US DEPARTMENT OF ENERGY
HANFORD WASTE VITRIFICATION PLANT

DESIGN CHANGE NOTICE

DCN - 0100 | REV 1 | PAGE 1 OF 18

DCN TITLE: THIS DCN-0100 SUPERSEDES "DCN-0096" & "DCN-0096 REV 1"

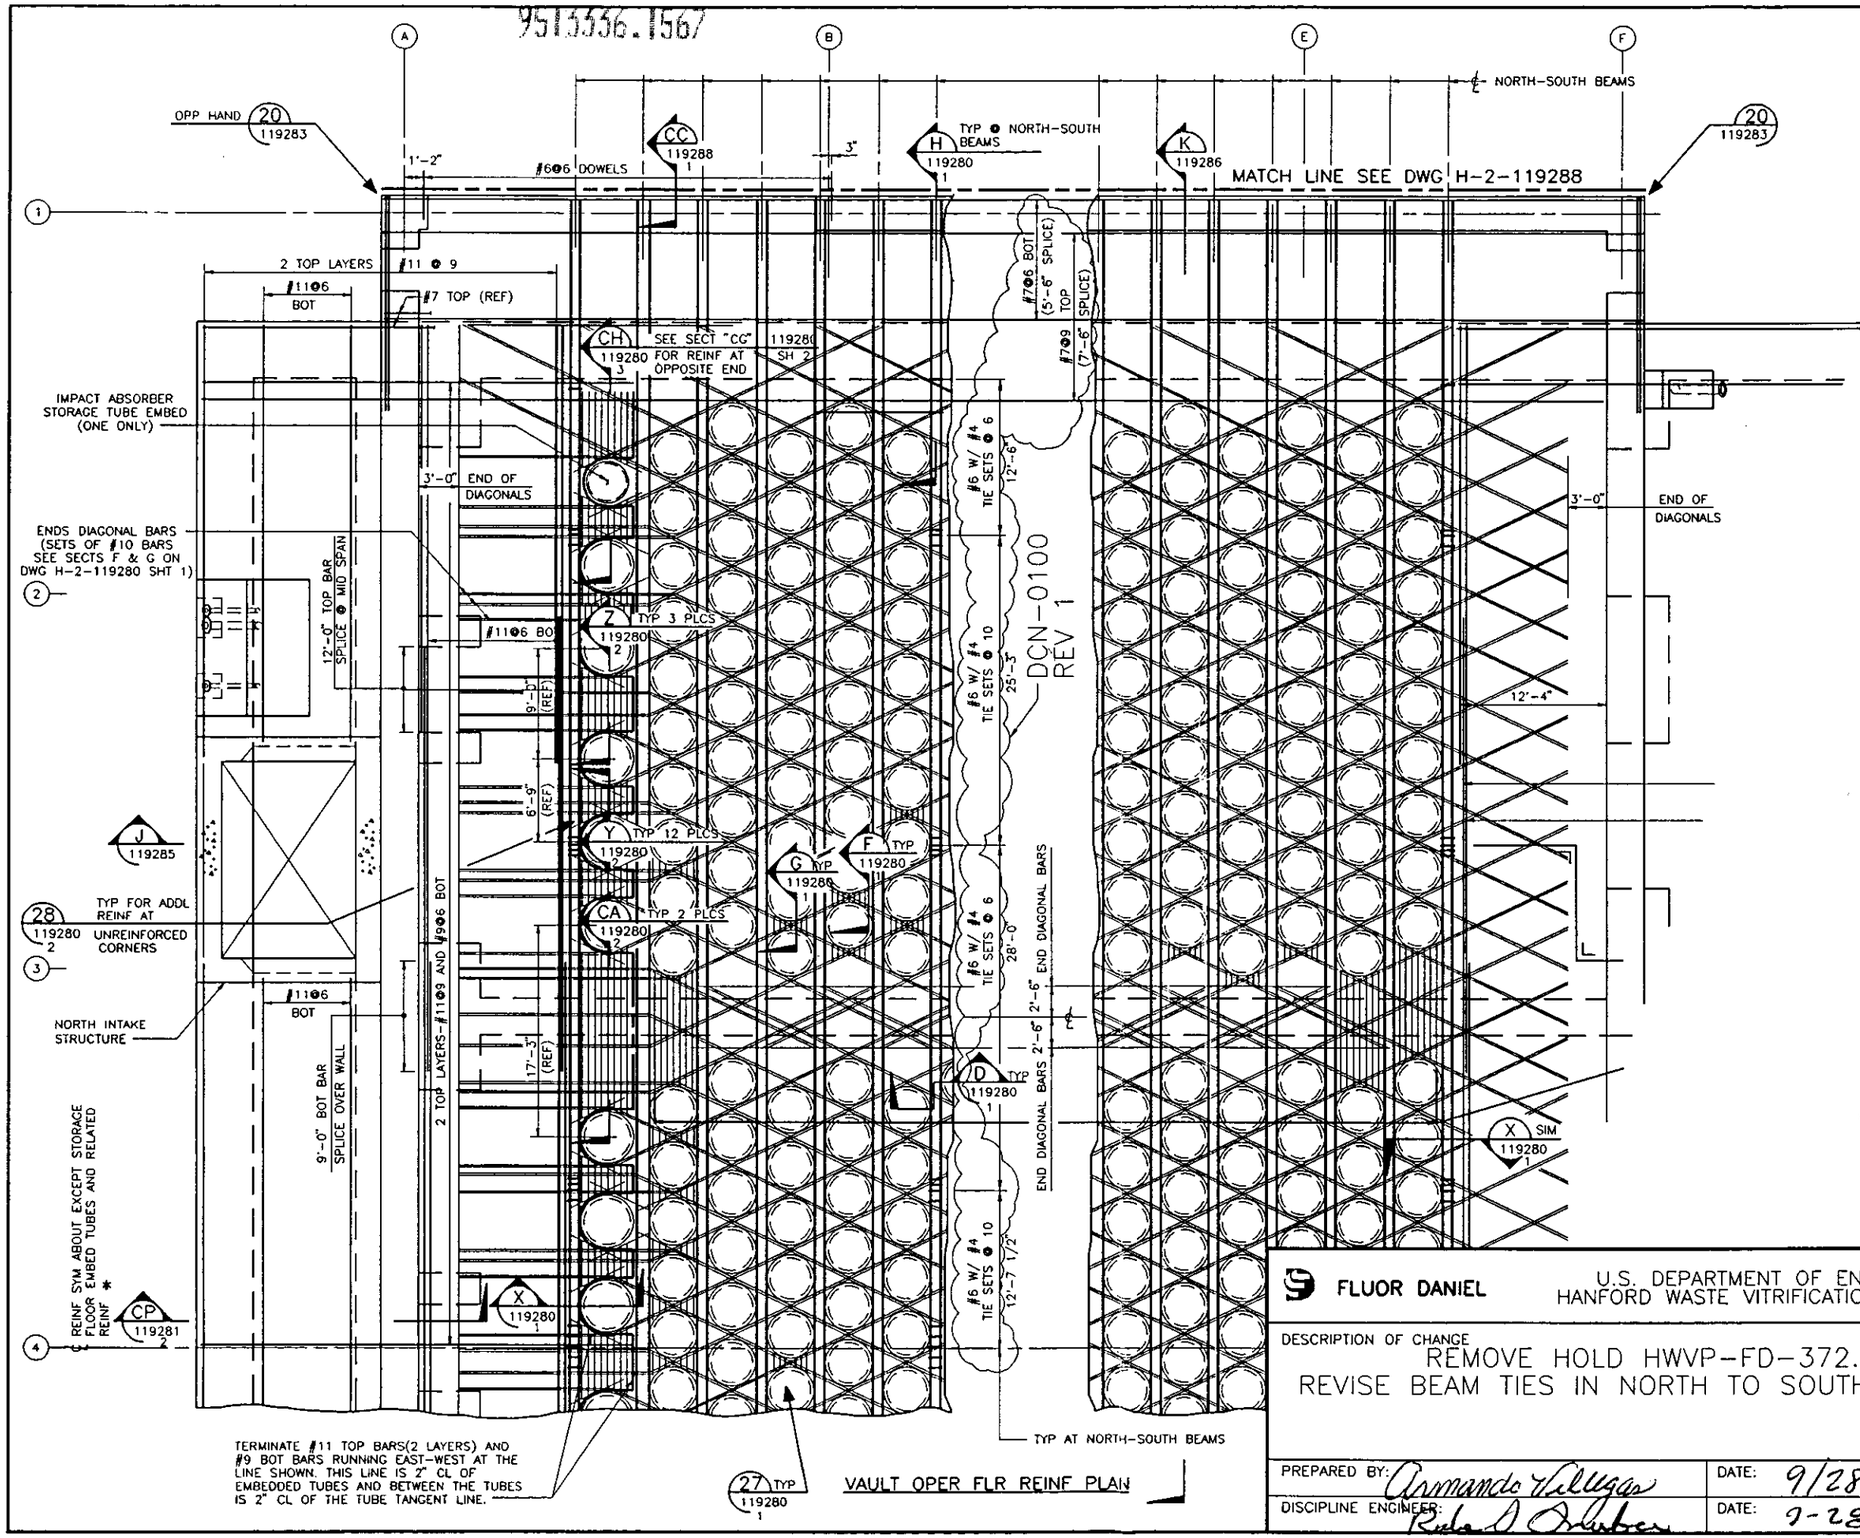
FLUOR DANIEL	U.S. DEPARTMENT OF ENERGY HANFORD WASTE VITRIFICATION PLANT	DESIGN CHANGE NOTICE
DESCRIPTION OF CHANGE REMOVE HOLD HWVP-FD-372. REVISE BEAM TIES IN NORTH TO SOUTH BEAMS.		BASE DOC. NO. H-2-119279 SHT/PG. 1 REV. 1 CR NO. CR-HWVP-1025 DISCIPLINE: STRUCTURAL/DCN0096M
PREPARED BY: Armando Villegas	DATE: 9/28/93	DCN - 0100 REV. 1 PAGE 6
DISCIPLINE ENGINEER: Richard Schuber	DATE: 9-28-93

* NOTE:
REINFORCING SHOWN FOR NORTH HALF IS SIMILAR FOR SOUTH HALF.
SEE DWG H-2-119276 FOR SOUTH HALF CONFIGURATION DIFFERENCES.

SECTION D 119279

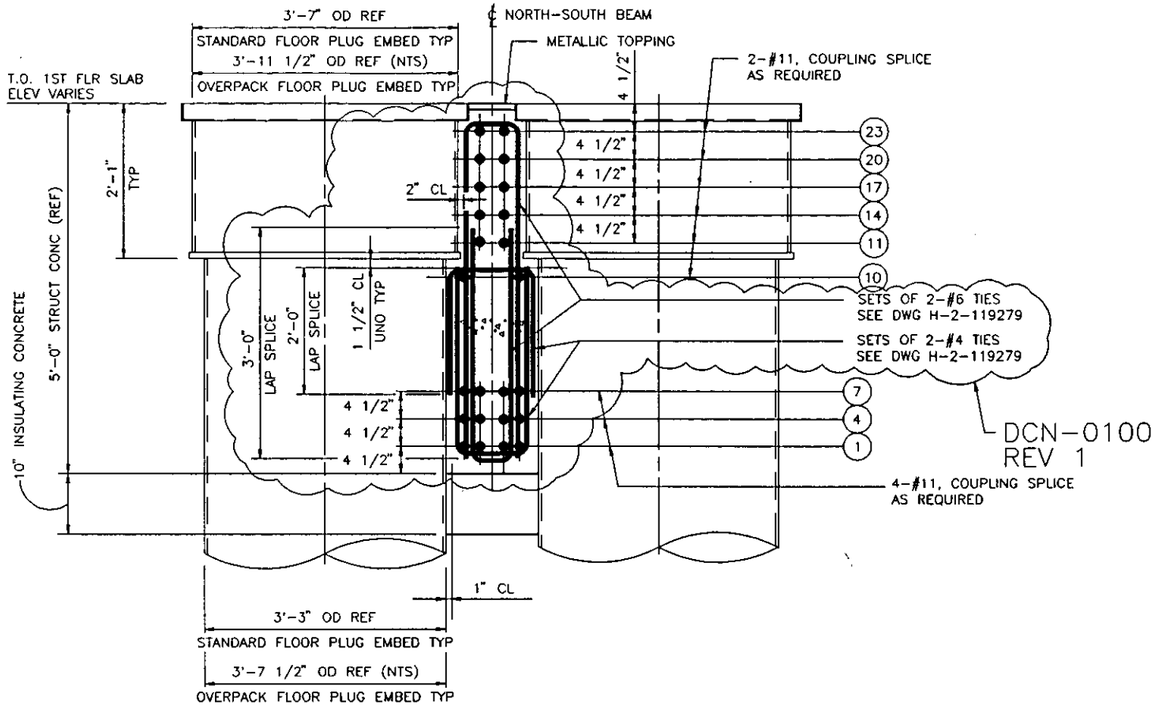
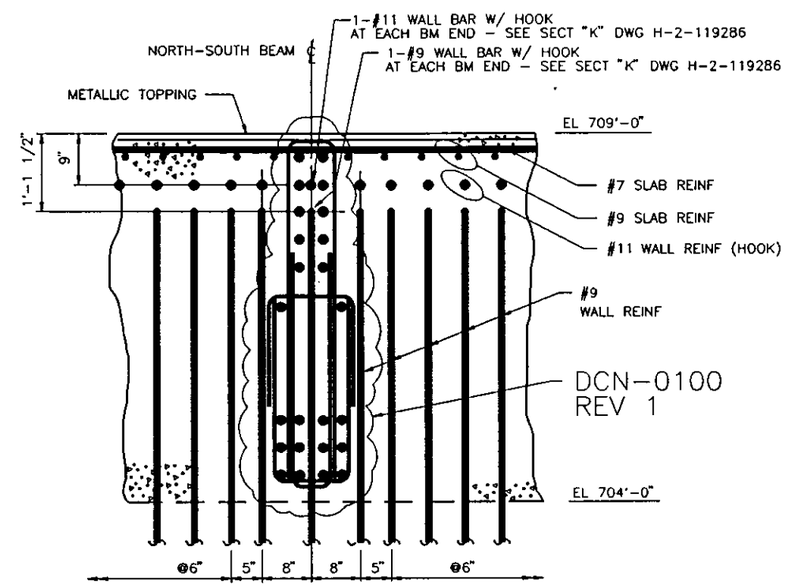
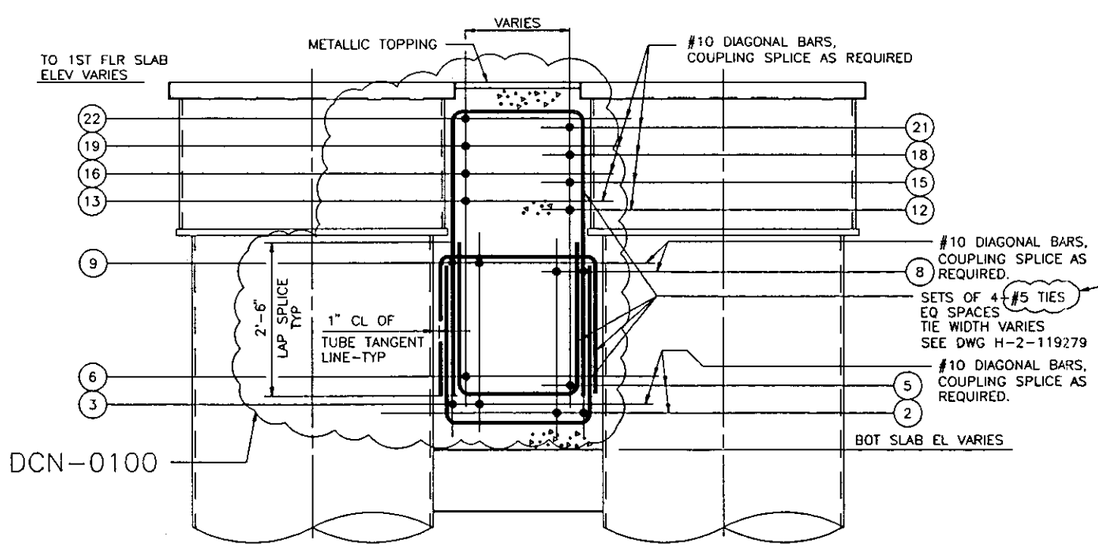
FLUOR DANIEL	U.S. DEPARTMENT OF ENERGY HANFORD WASTE VITRIFICATION PLANT	DESIGN CHANGE NOTICE
DESCRIPTION OF CHANGE REMOVE HOLD HWVP-FD-372. REVISE REINFORCING TIES.		BASE DOC. NO. H-2-119280 SHT/PG. 1 REV. 1 CR NO. CR-HWVP-1025 DISCIPLINE: STRUCTURAL/DCN0096N
PREPARED BY: Armando Villegas	DATE: 9/28/93	DCN - 0100 REV. 1 PAGE 7
DISCIPLINE ENGINEER: Robert J. Smuber	DATE: 9-28-93

SECTION G 119279

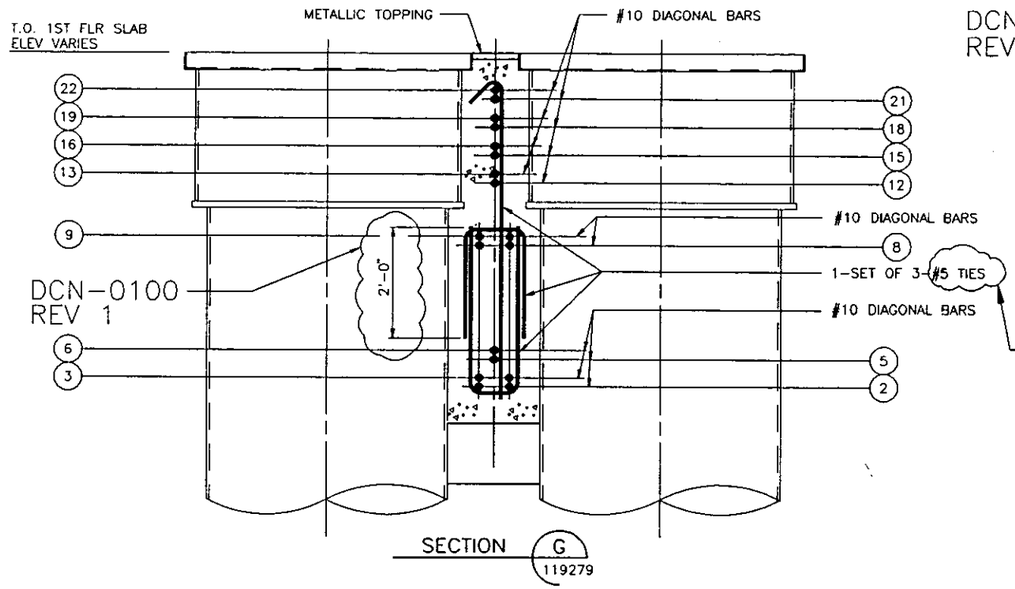
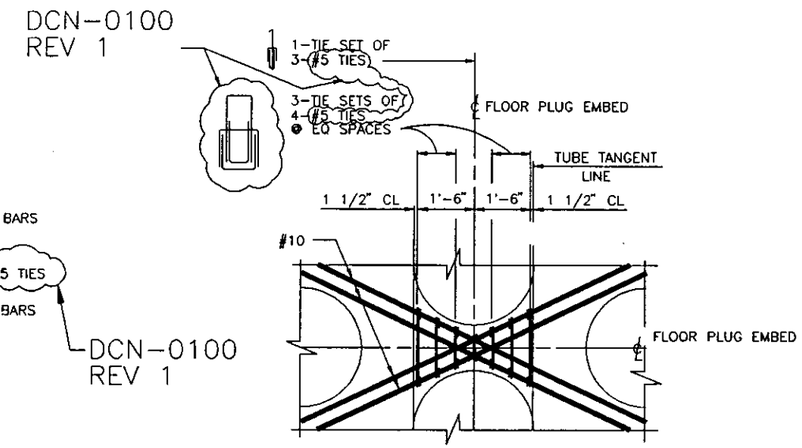
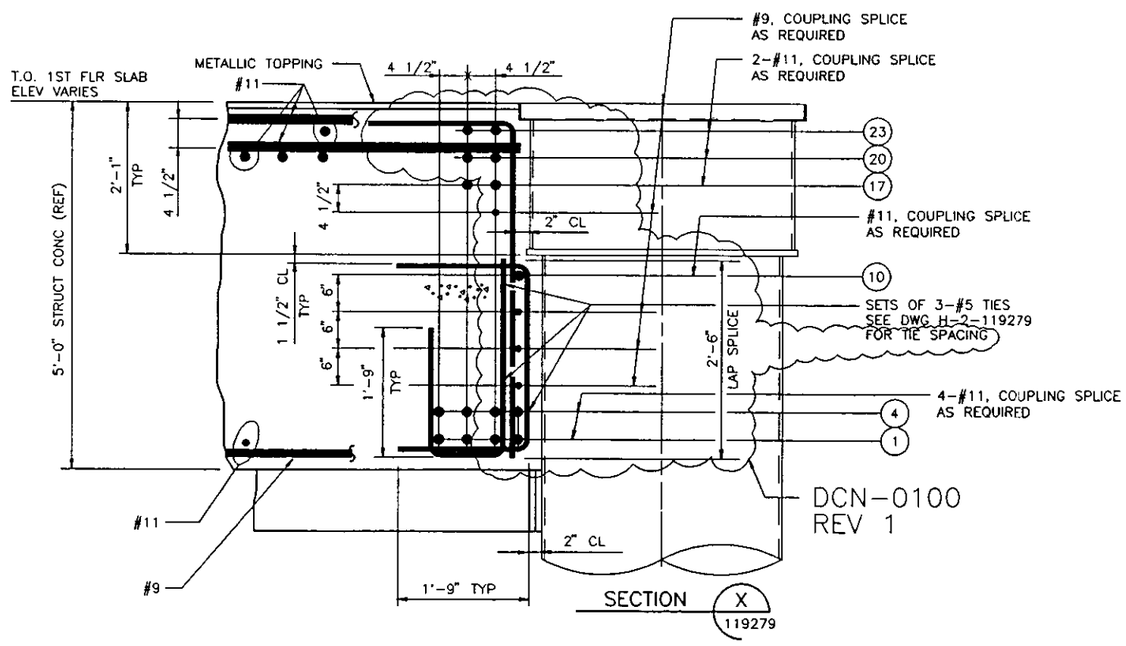
FLUOR DANIEL	U.S. DEPARTMENT OF ENERGY HANFORD WASTE VITRIFICATION PLANT	DESIGN CHANGE NOTICE
DESCRIPTION OF CHANGE REMOVE HOLD HWVP-FD-372. REVISE REINFORCING TIES.		BASE DOC. NO. H-2-119280 SHT/PG. 1 REV. 1 CR NO. CR-HWVP-1025 DISCIPLINE: STRUCTURAL/DCN00960
PREPARED BY: Armando Villegas	DATE: 9/28/93	DCN - 0100 REV. 1 PAGE 8
DISCIPLINE ENGINEER: Robert Gruber	DATE: 9-28-93

DETAIL SHOWN AT PLACEMENT LAYERS (8) AND (9)
NORTH-SOUTH BEAMS OMITTED FOR CLARITY

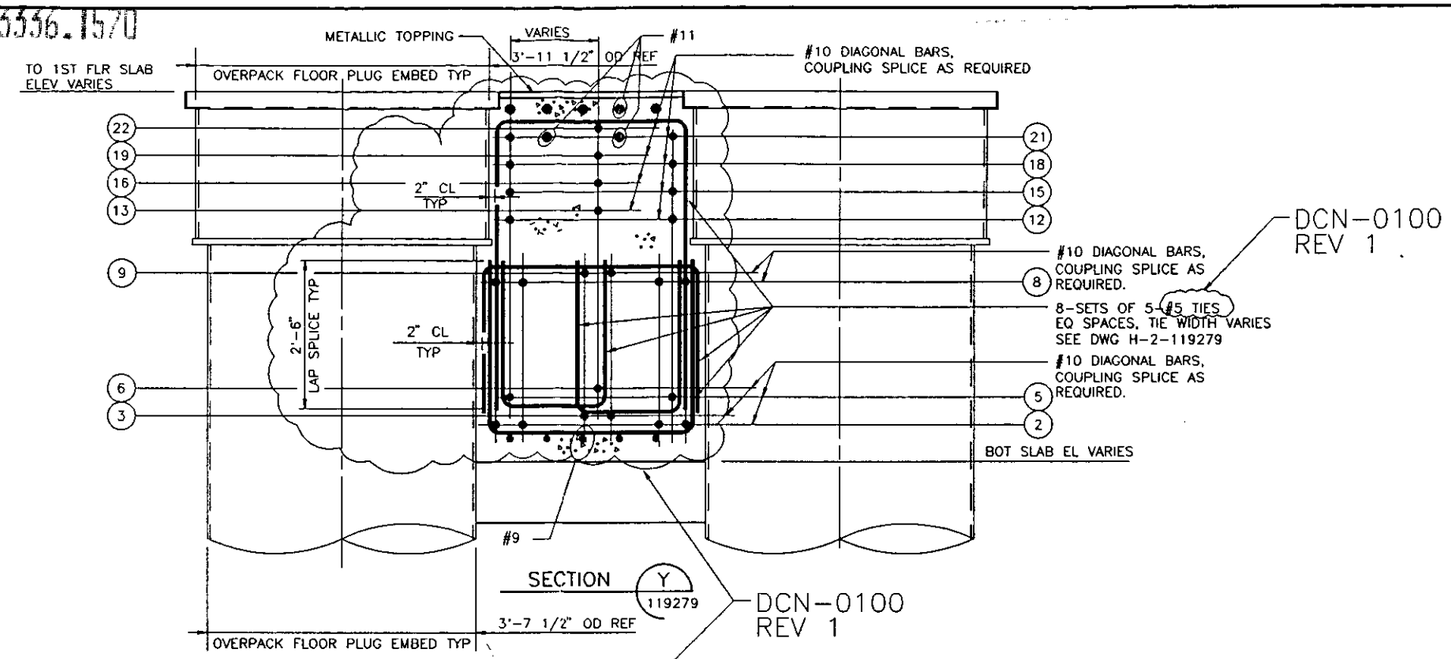
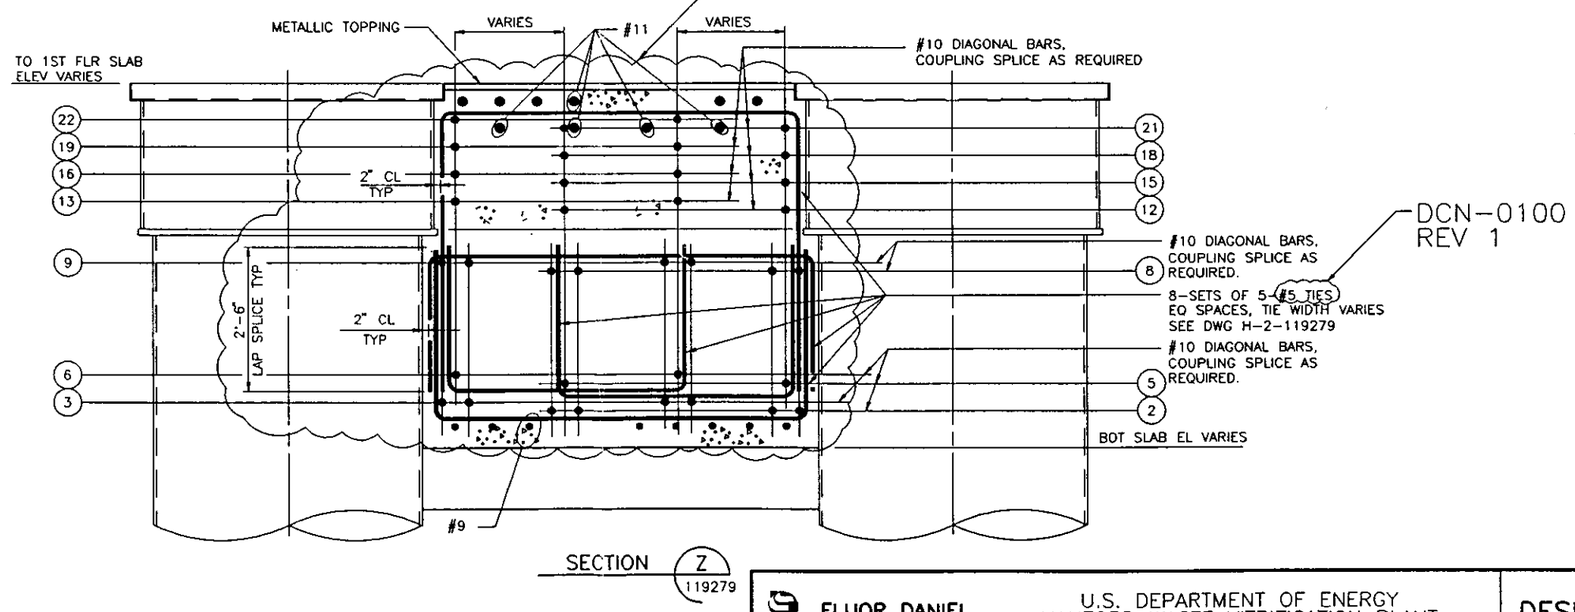
FLUOR DANIEL	U.S. DEPARTMENT OF ENERGY HANFORD WASTE VITRIFICATION PLANT	DESIGN CHANGE NOTICE
DESCRIPTION OF CHANGE REMOVE HOLD HWVP-FD-372. REVISE REINFORCING TIES.		BASE DOC. NO. H-2-119280 SHT/PG. 2 REV. 1 CR NO. CR-HWVP-1025 DISCIPLINE: STRUCTURAL/DCN0096P
PREPARED BY: Armando Villegas	DATE: 9/28/93	DCN - 0100 | REV. 1 | PAGE 9
DISCIPLINE ENGINEER: Robert J. Lindberg	DATE: 9-28-93

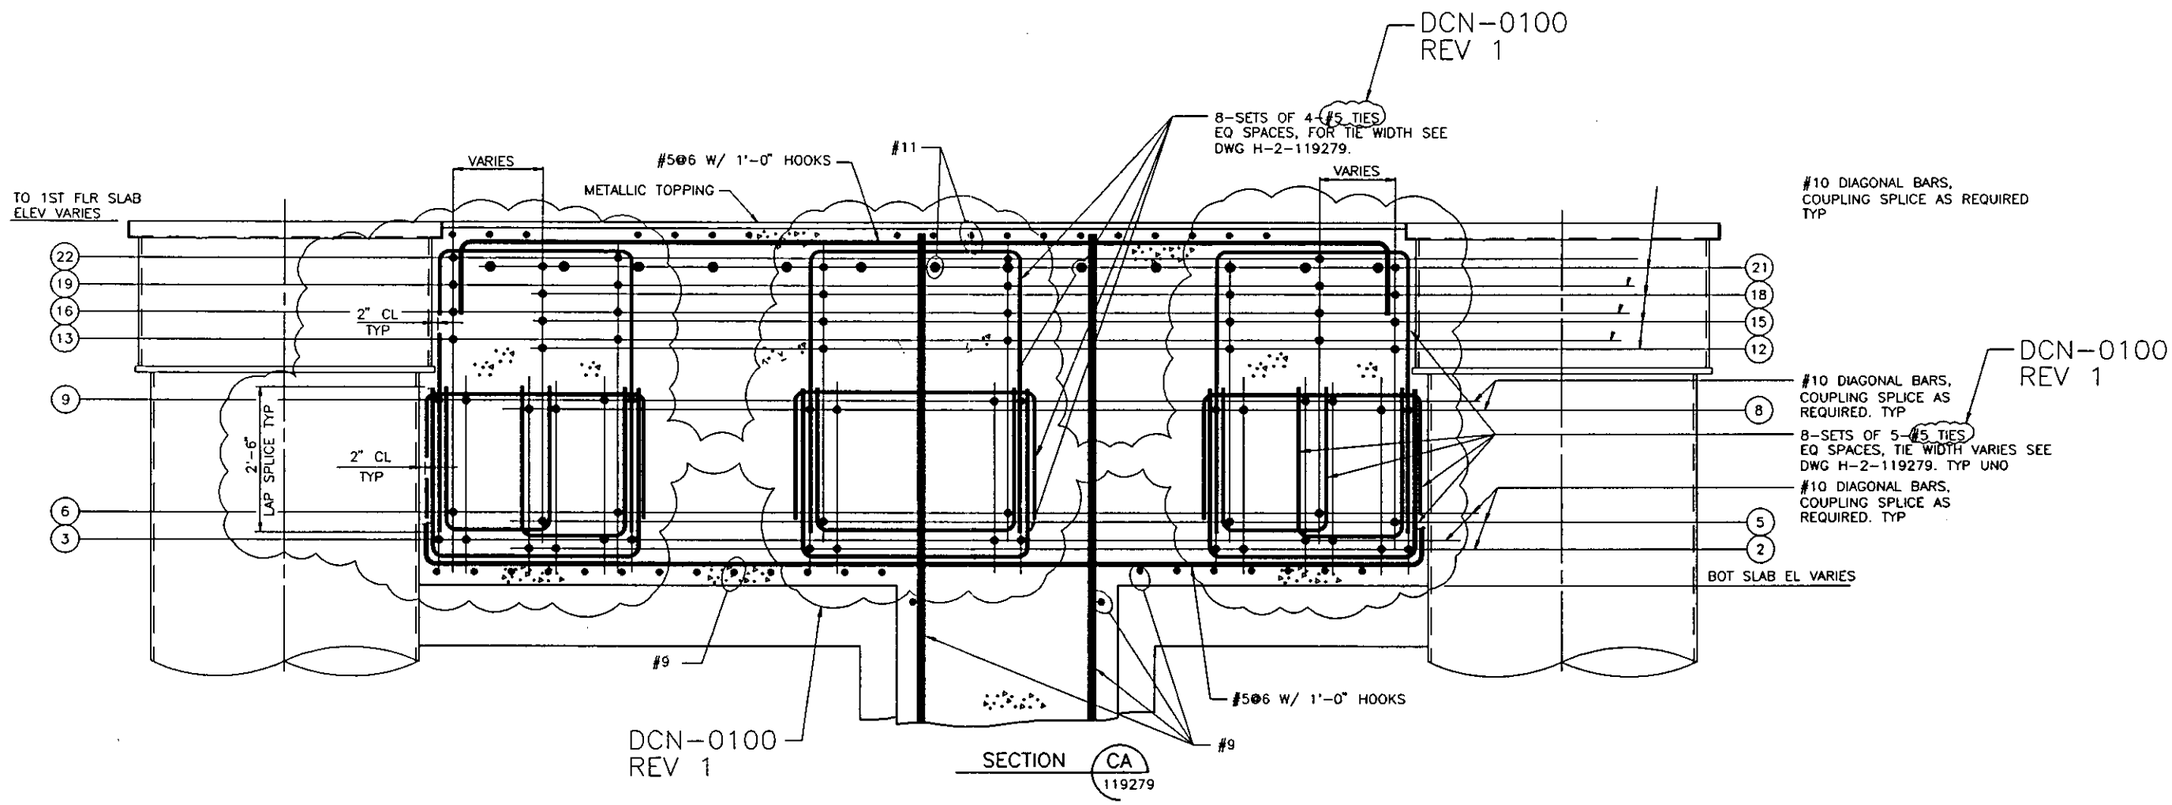
FLUOR DANIEL	U.S. DEPARTMENT OF ENERGY HANFORD WASTE VITRIFICATION PLANT	DESIGN CHANGE NOTICE
DESCRIPTION OF CHANGE REMOVE HOLD HWVP-FD-372. REVISE REINFORCING TIES.		BASE DOC. NO. H-2-119280 SHT/PG. 2 REV. 1 CR NO. CR-HWVP-1025 DISCIPLINE: STRUCTURAL/DCN0096Q
PREPARED BY: Armando Villegas	DATE: 9/28/93	DCN - 0100 / REV. 1 / PAGE 10
DISCIPLINE ENGINEER: Robert A. Bruebaker	DATE: 9-28-93
